SAF Intra Range Suspension Product Update Notice

Product: Intra Range Axles & Suspensions

Model: Intradisc Integral & Intradrum

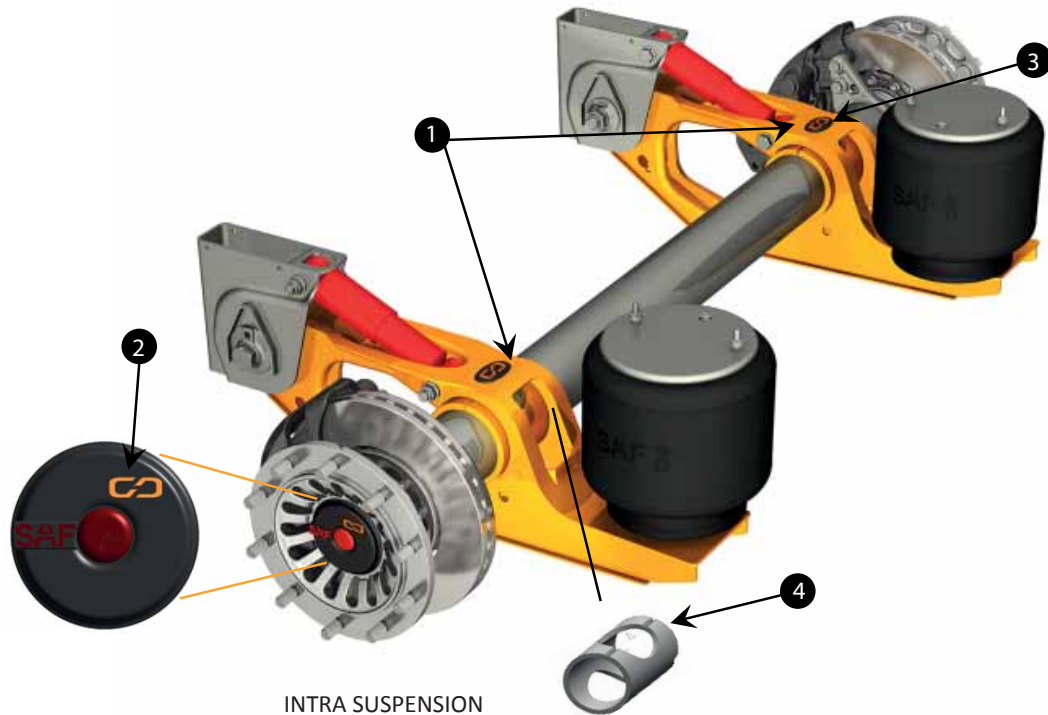
Due to the latest design change, SAF-HOLLAND is in a position to further decrease the overall weight of the Intra range suspension.

This is achieved by removing the reinforcement plate, improved material top plate and new axle bush orientation.

The new 'CD' can be visually identified with the following changes:

1. Removal of reinforcement plate;
2. Custom Design cap design;
3. CD Clip
4. New orientation of the welds on the axle bush for less stress and improved durability

No changes to BOM or part numbers, fit or function of the Intra Suspension
